Provision of quarters for Inspectors & Sub Inspectors of the Station Police –
Change of site of the Cubbon Park Police station

Submitting plans and Estimate for improvement of Cubbon Park Police Station

Removal of the Cubbon Park Police Station to a site to the north of Prospect House.

Rebuilding of the Cubbon Park Police Station

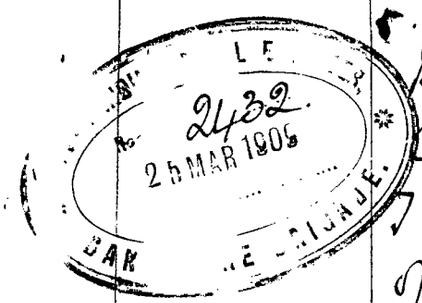
3. In these papers (1) the inclusion of area 2 (2) the reduction of the proposed area [exclusion of 2] from c. 860 sq yds to c. 602 sq. yds : effected not only by (1) reducing the projection into the Carlton frontage but also (ii) the frontage along Stirling Road. — It will probably be sufficient if ascertain from S.P. whether the area A B C D E on the plan will be sufficient

(2) As the Dwg does not show the extent of the Carlton frontage exactly the attached sketch is for Cl.

There is no objection to the inclusion of the area Z & the reduction of the area on the line C.B. facing Cubbon Park but I think the area outside the line A.B should be retained by us. As the Dewan objection is that the proposed station goes too far into the park he will probably not object to this proposal

6. The area A B F G. is opposite the main entrance of the proposed Police Stn., & the retention of this space is advisable. & will not lead to the removal of any additional trees from the proposed site.

7. Write to the Dewan that Resident agrees that the proposed reduction of the projection into Cubbon

IMPROVEMENTS TO

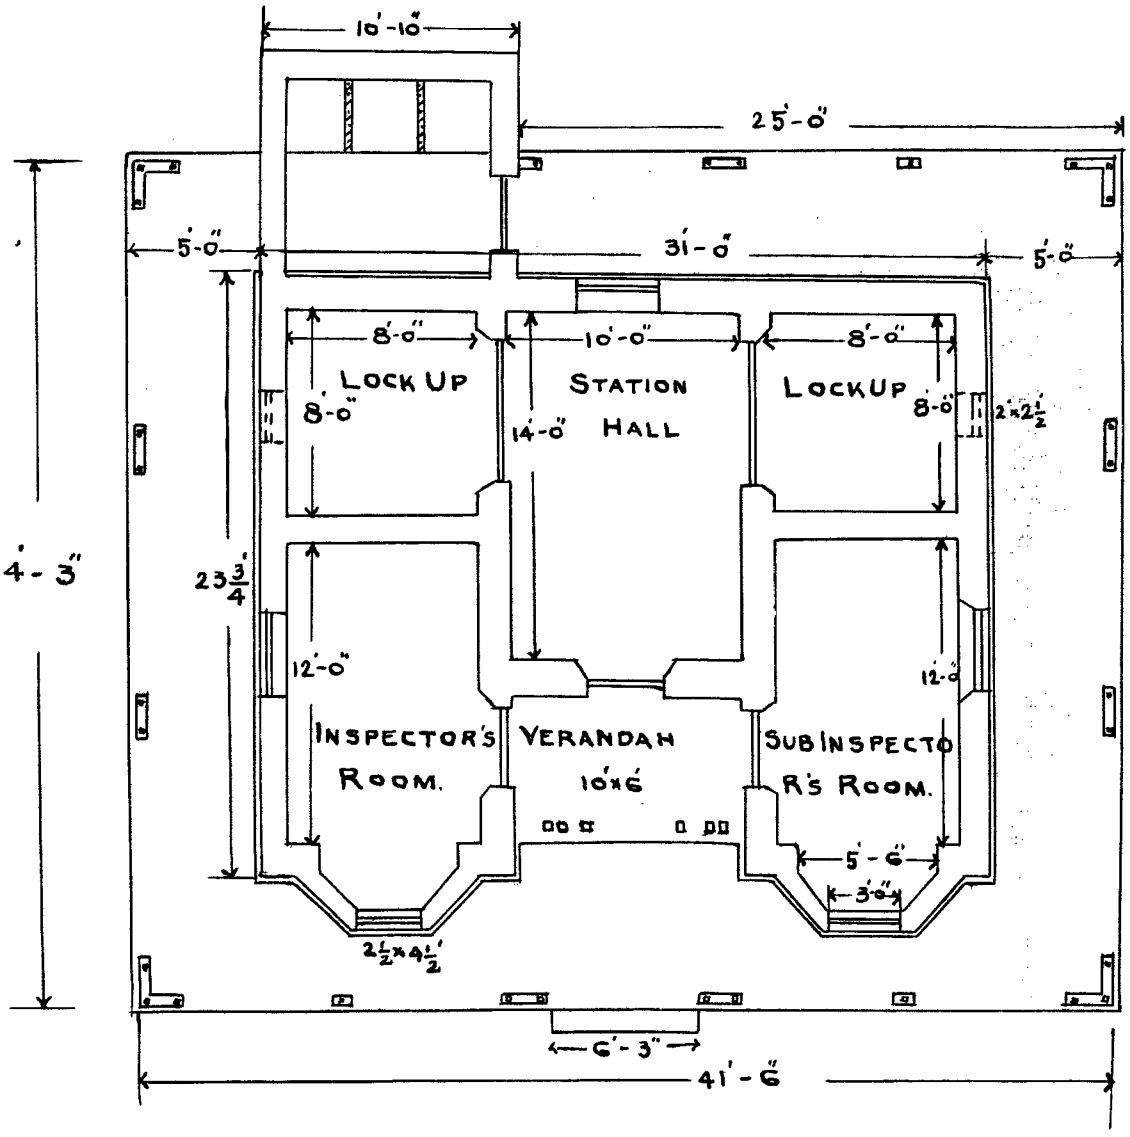
Please see ~~Office note (Nos 3)~~ Resolutions Pt. Nos. 48 and 49. In conformity with instructions contained in Pt. 48, the Collector has obtained plans and an Estimate accounting to Rs 928 for the improvement of Cubbon Park Police station. The Collector however, is not in favor of the improvements.

2 The only objection is that it will make the place less unsightly and

3 the changes now contemplated are likely to affect the object. The Coll: has not considered this aspect of the case nor does he feel competent to say whether anything is to be done to improve the look of the Garden.

6 I think it would be a mistake to support to a landlord an objection of this sort. I should leave it to Collector & A.C.R.E. If they think there is no real objection let the plan be carried out. If they think there is let it be altered.

It may be taken for granted that any tenant, whether European or Indian, would make the landlord subject to a balcony overlooking Prospect House. The Plan may therefore be altered so that the balcony on the side of the Police Station which faces Prospect House is either omitted, or, if required for external symmetry, is set back.

Proposed Improvements — It is considered that a 5'
Verandah all round with lat
work between pillars will give
the desired effects.
